SUBJECT: Waterford SES Unit No. 3
Docket No. 50-382
Significant Construction Deficiency No. 88
"Refueling Water Storage Pool Nozzle/Liner Overstressed Condition"

In response to the specific questions raised by the NRC inspector during the review of SCD-88, a recalculation was performed using the resultant of the two bending moments as the maximum bending moment.

The reanalysis results indicate that the actual stresses are still within allowable stress limit.

SUBJECT STRESS ANALYSIS FOR NOZZLE PE-7

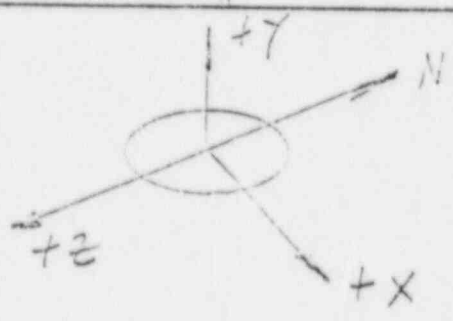
NOT CORRELATING WITH SOME OF THE DATA

PF 2

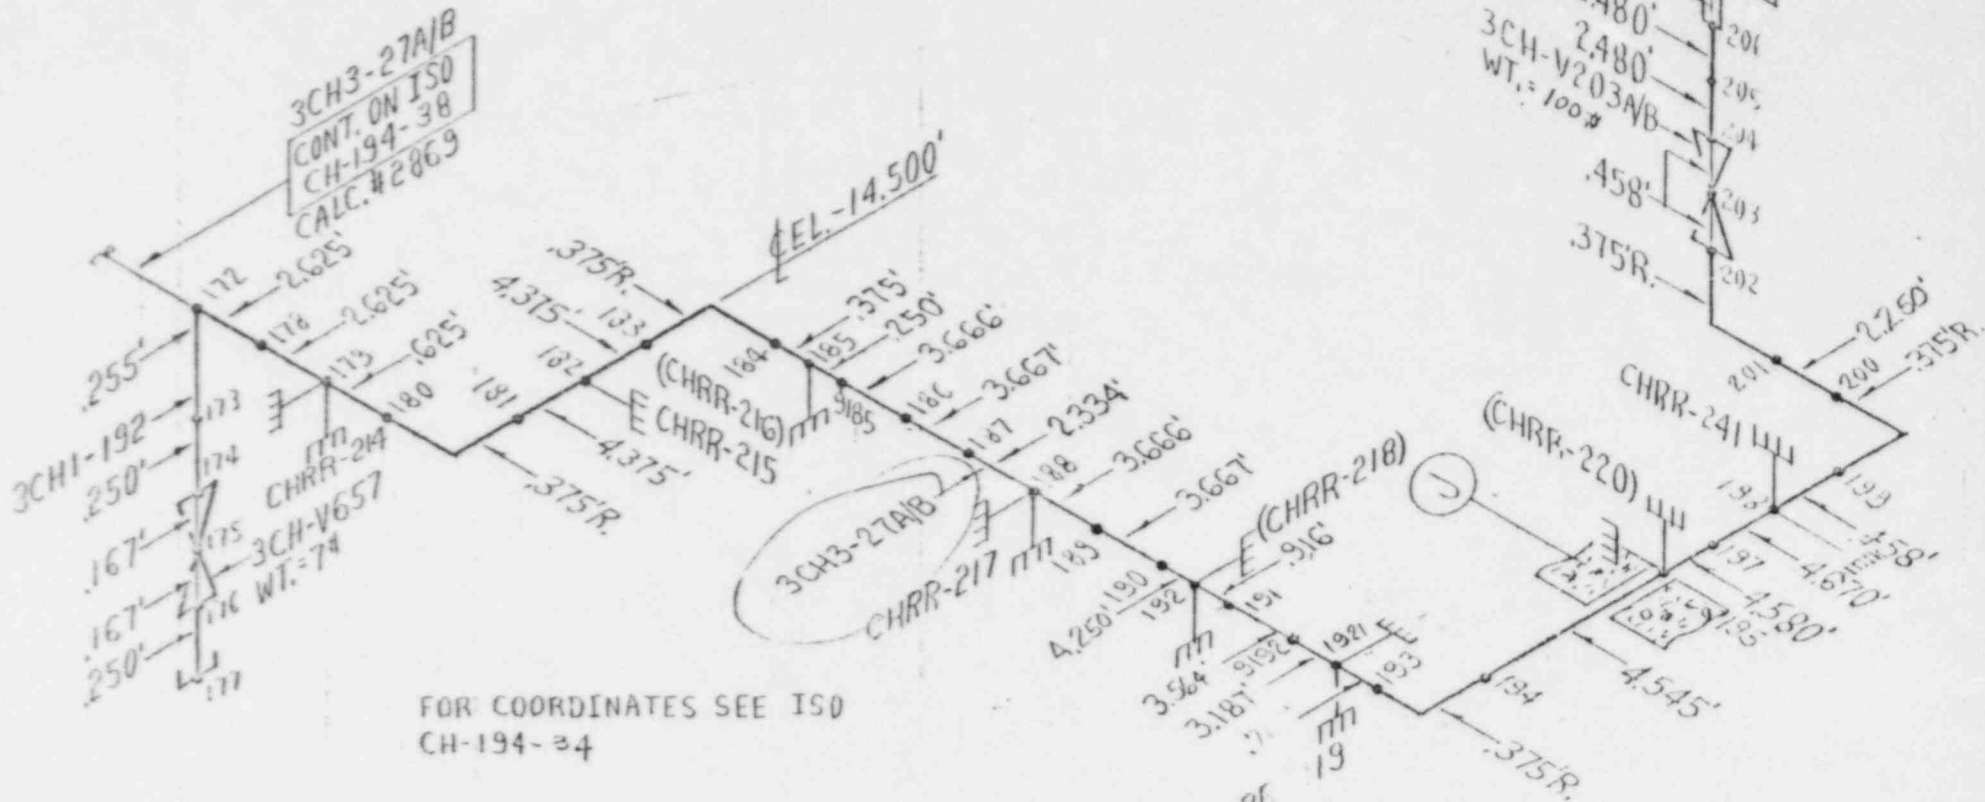
CHECK STRESS DUE TO BENDING IN PIPE AT HORIZONTAL

RESULTANT MOMENT
333 FT·lb = 4.6 in·k

$\sigma_r = \frac{69 \times 4.6}{40\pi \times 1.75 \times .25} = \log 2 \left(\frac{4.3125 - 1.75}{0.4 \times 4.3125} \right)$
 $= 25.15 ksi < 26.75 ksi$ OK

$= 29.02 ksi < 32.5 ksi$ OK

SINCE THE STRESSES FOR PF-3, PF-6, PF-7, PF-11, PF-20 & PF-21 ARE SMALLER THAN THAT OF PF-2, FURTHER ANALYSIS IS NOT REQUIRED.

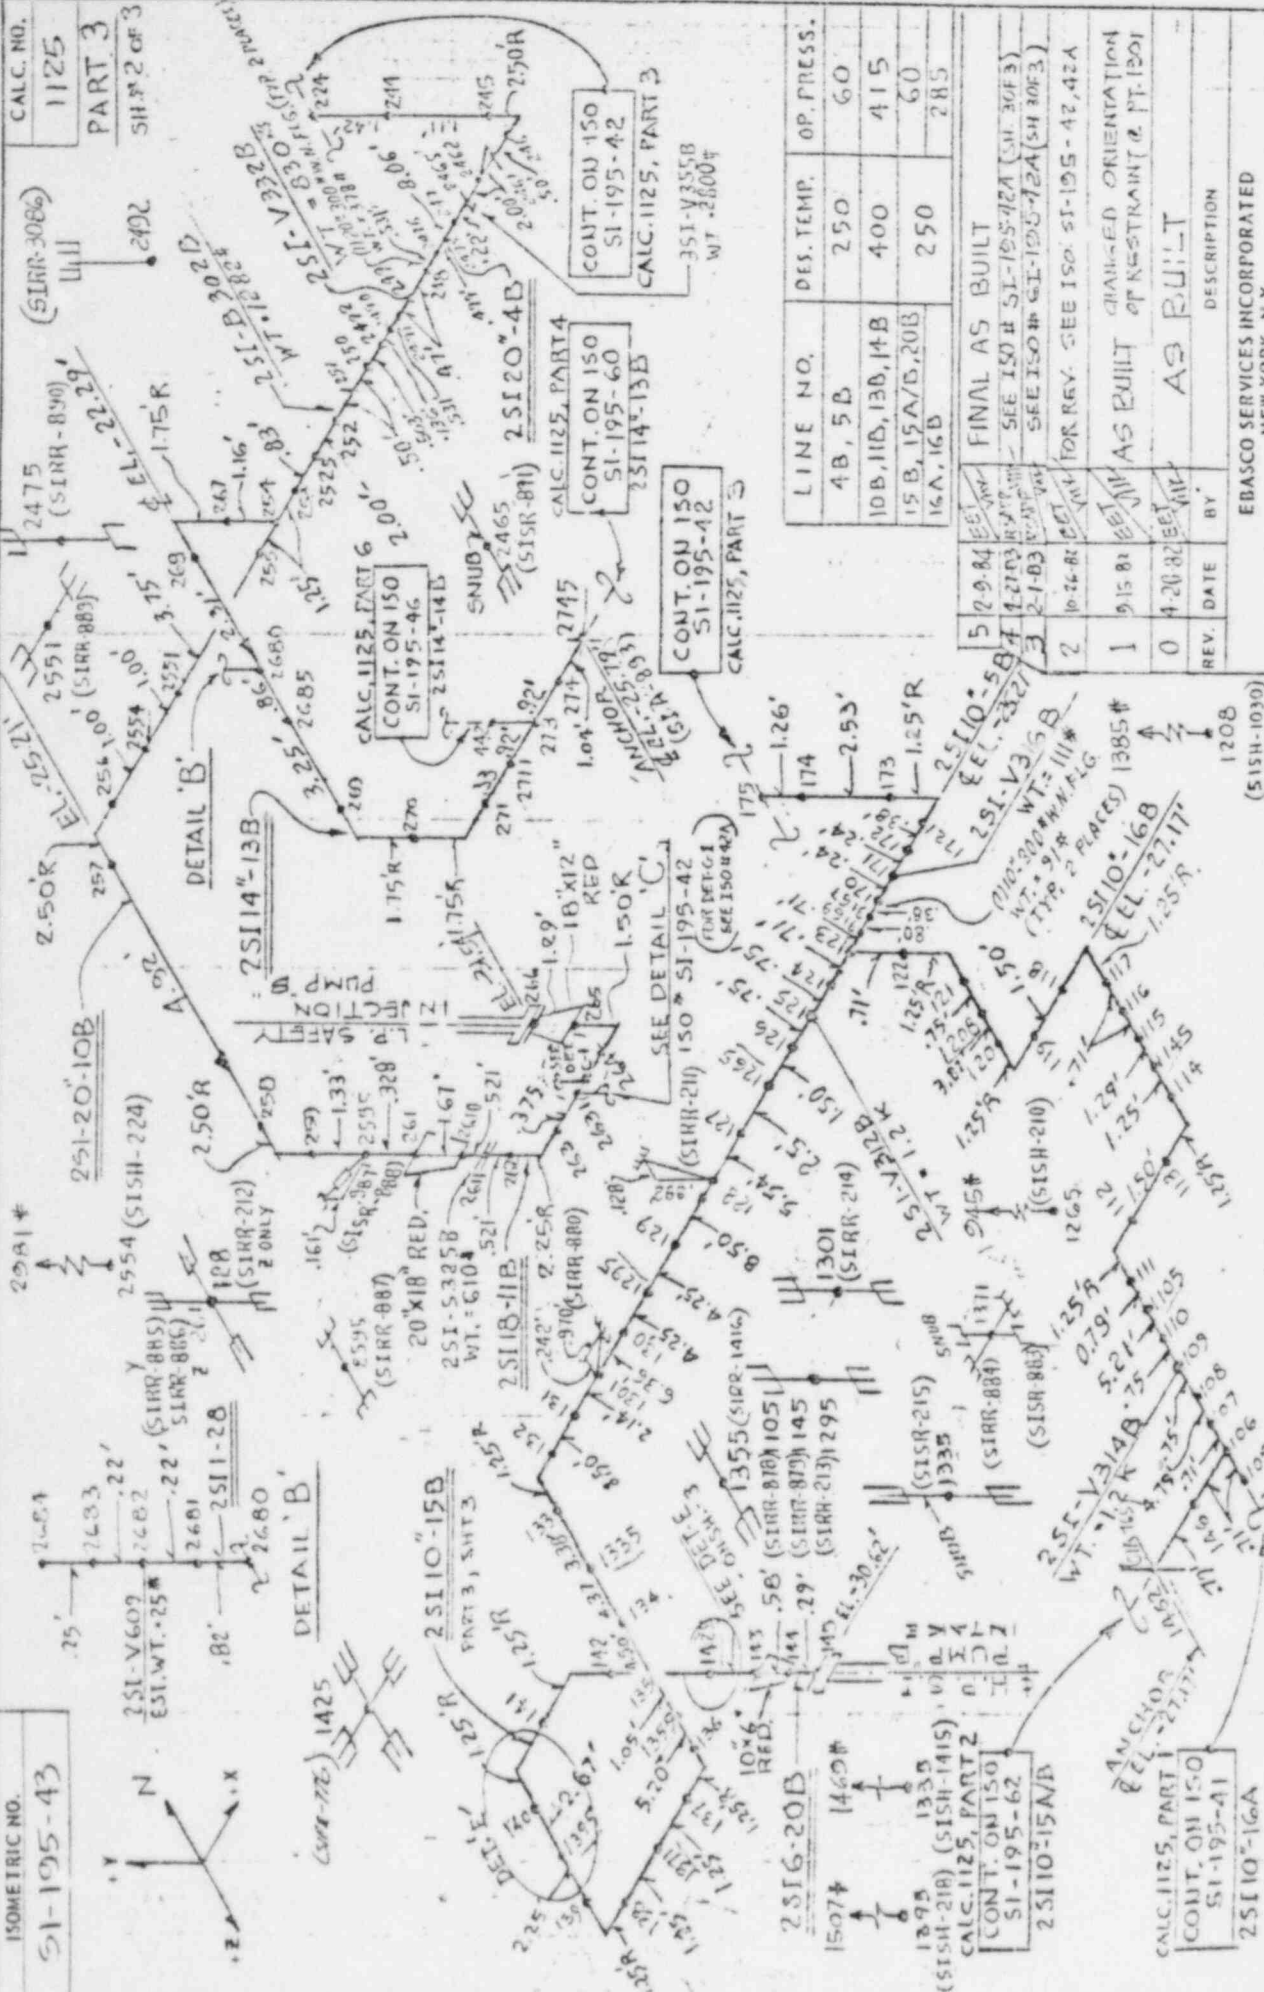
LOADS ARE REDUCED PER STRESS CLAC REV #5 (2-9-84)

RESULTANT MOMENTS ARE LESS THAN ORIGINAL

SUBJECT NOZZLE LOSS P-3

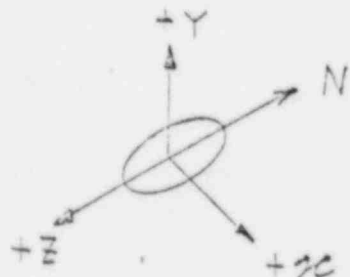
SEE P-4 CALC.

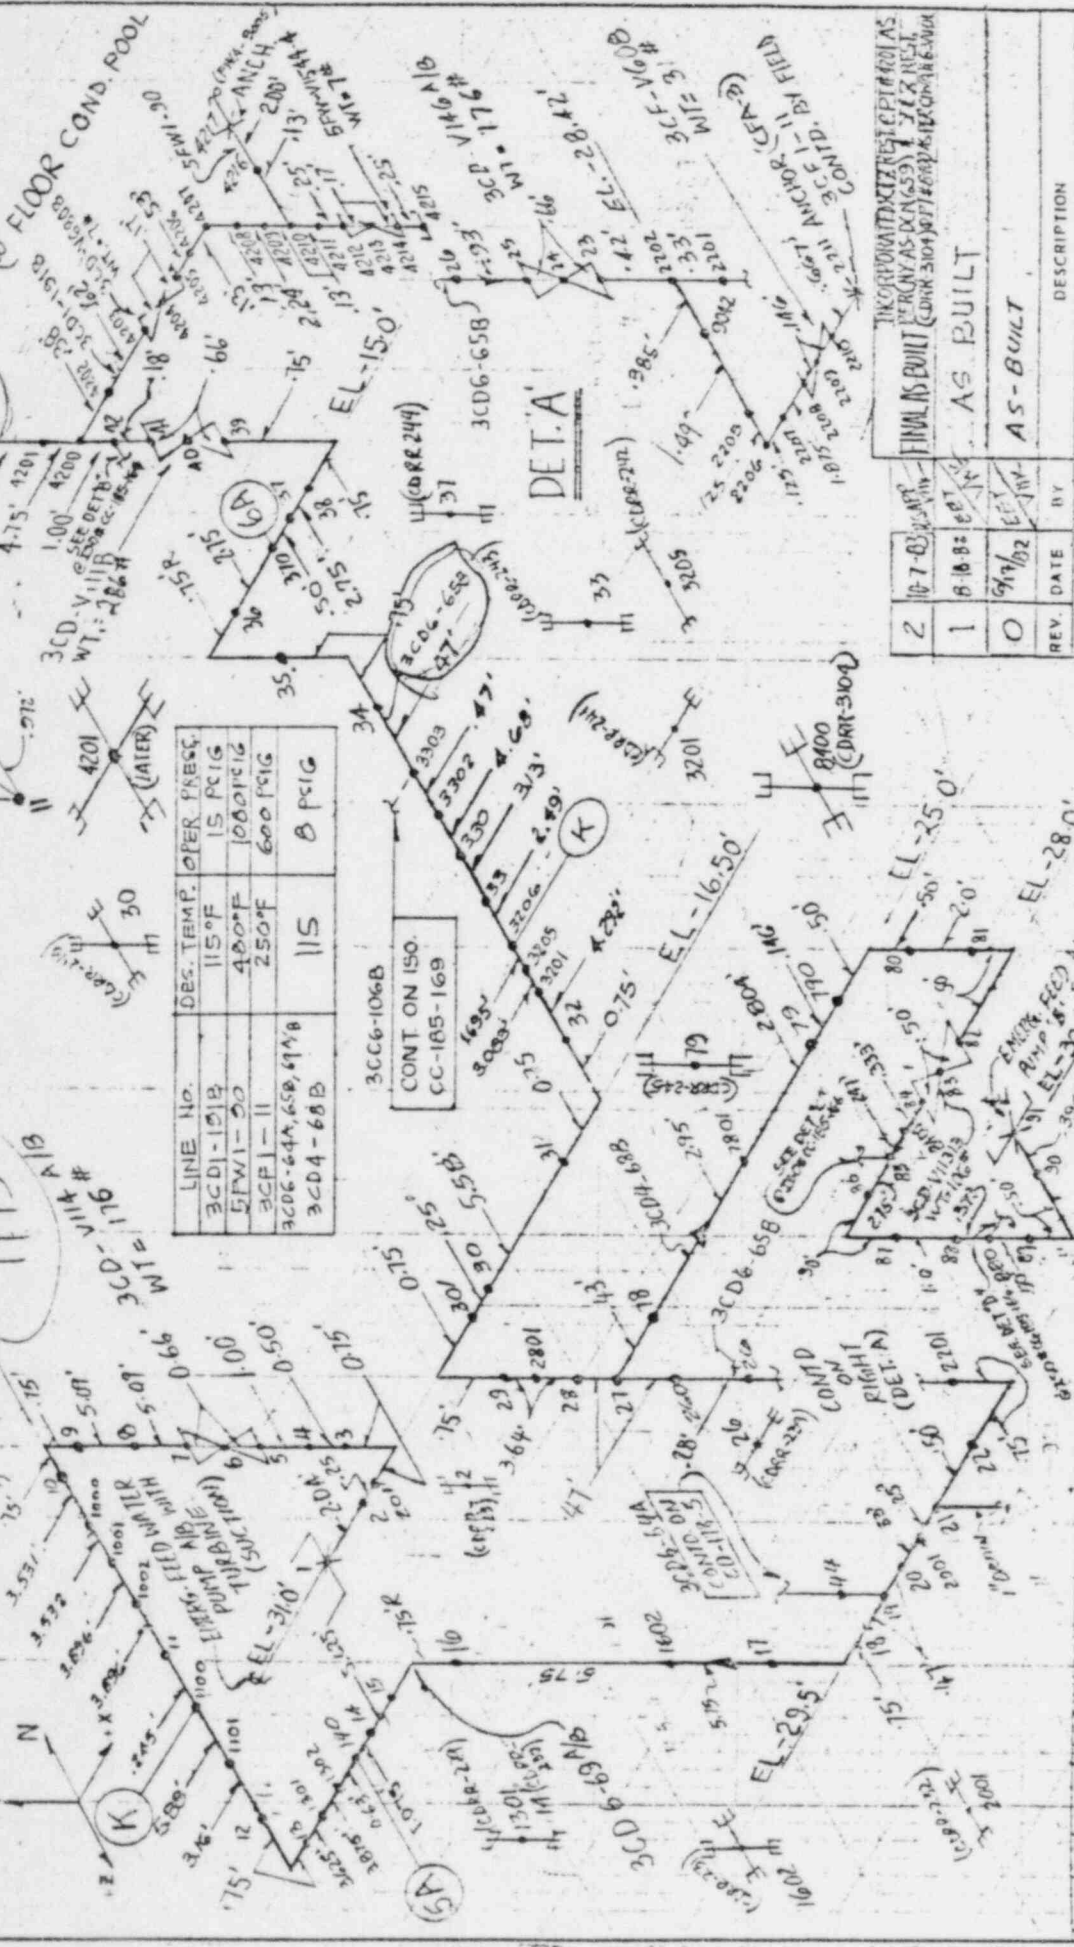
LOADS HAVE BEEN REDUCED PER STRESS CALC REV #2 10.7.84
 RESULTANT MOMENTS ARE LESS THAN MOMENTS USED IN
 ORIGINAL CALCS NO NEED FOR FURTHER ANALYSIS.

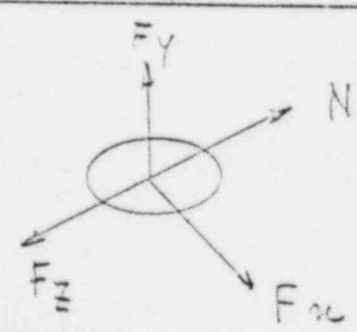
NO NEED TO CHECK, RESULTANT MOMENTS SAME AS THE GREATER OF THE TWO BENDING MOMENTS

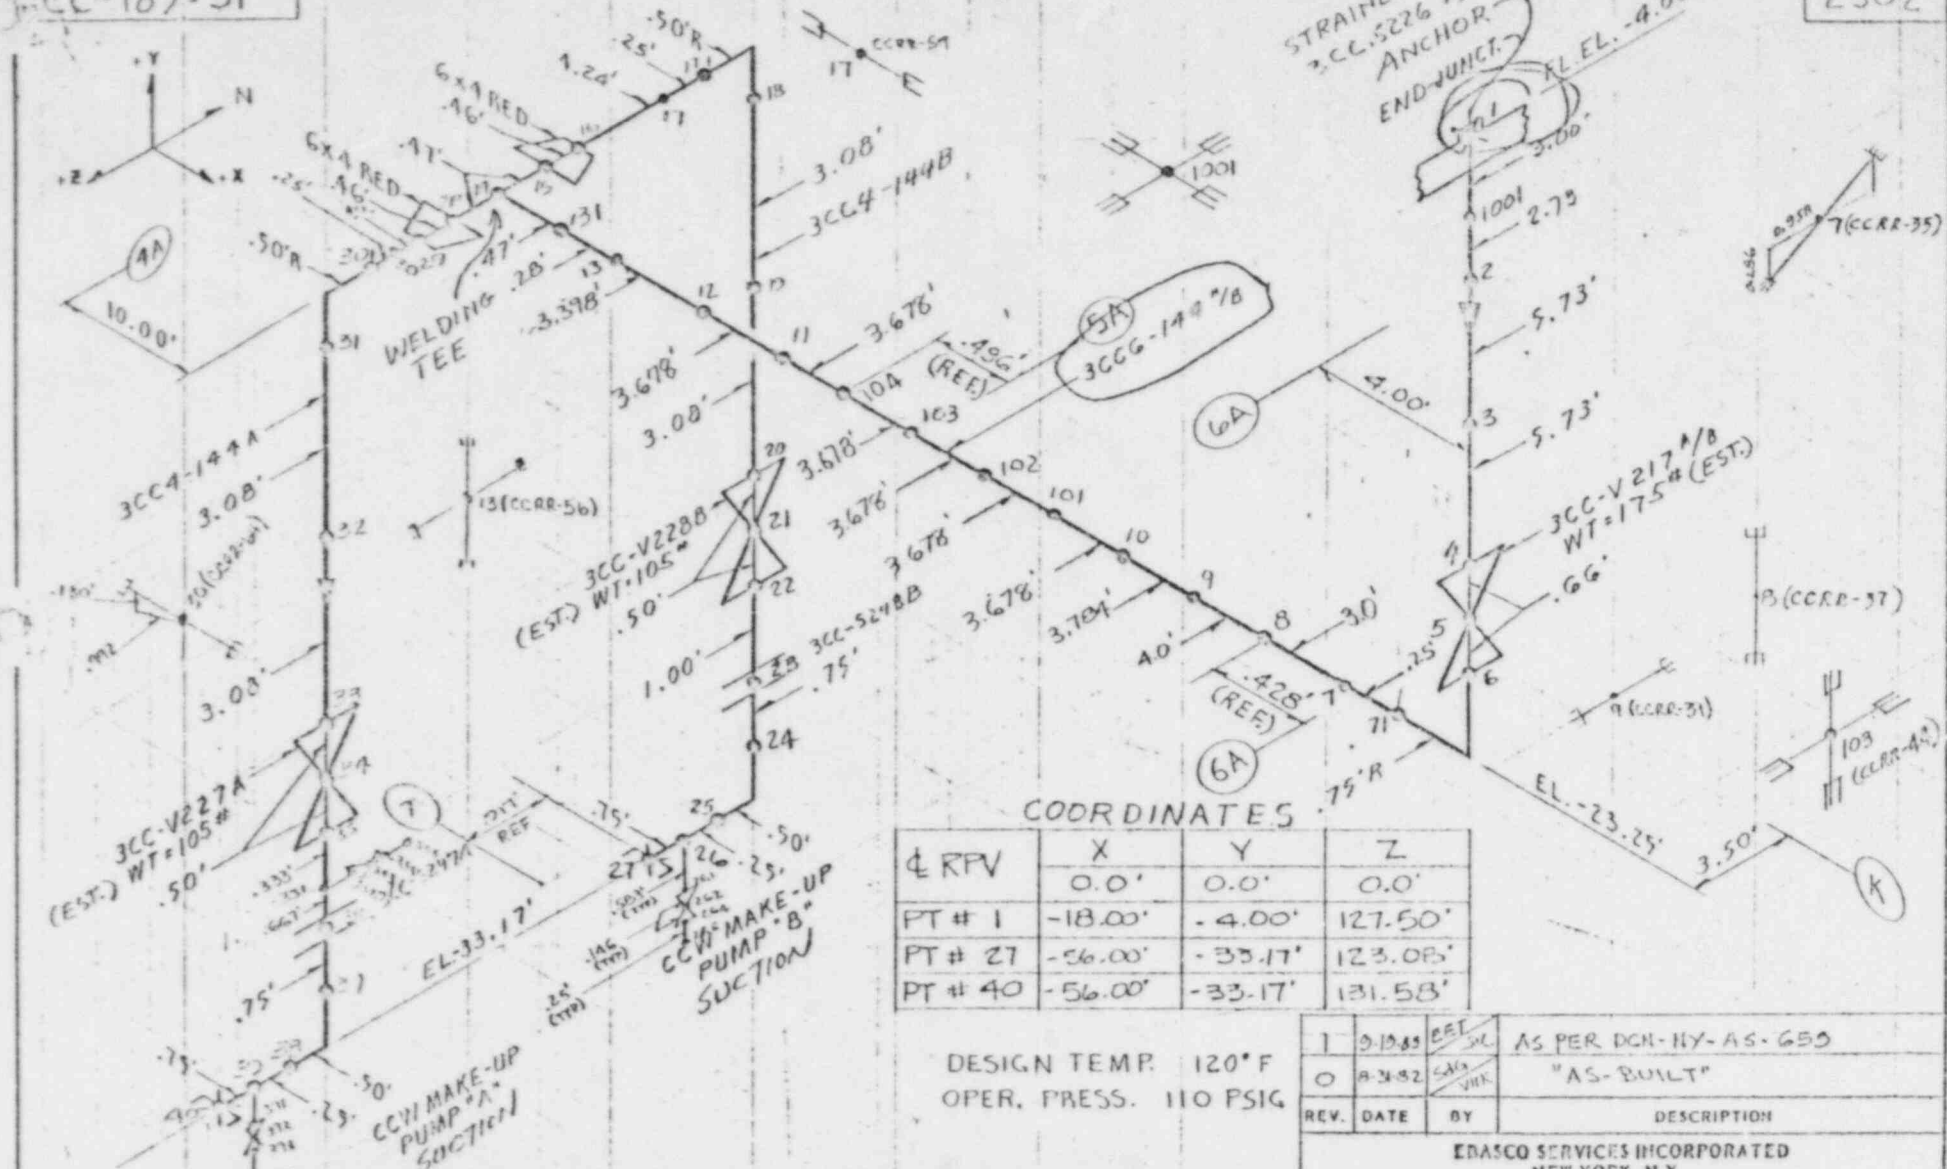
Resultant Moments same as the direction of the two bending moments to be used for stress analysis.

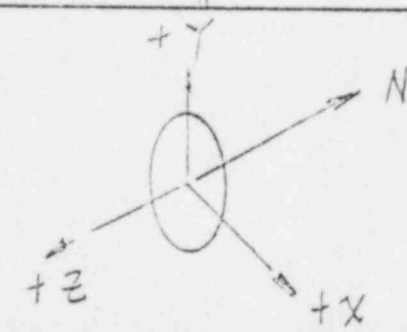
LOADS HAVE BEEN REDUCED PER STRESS CALC REV #1-12-79-83
 RESULTANT MOMENTS ARE LOWER THAN MOMENTS USED IN ORIGINAL CALCS. NO NEED FOR FURTHER ANALYSIS.
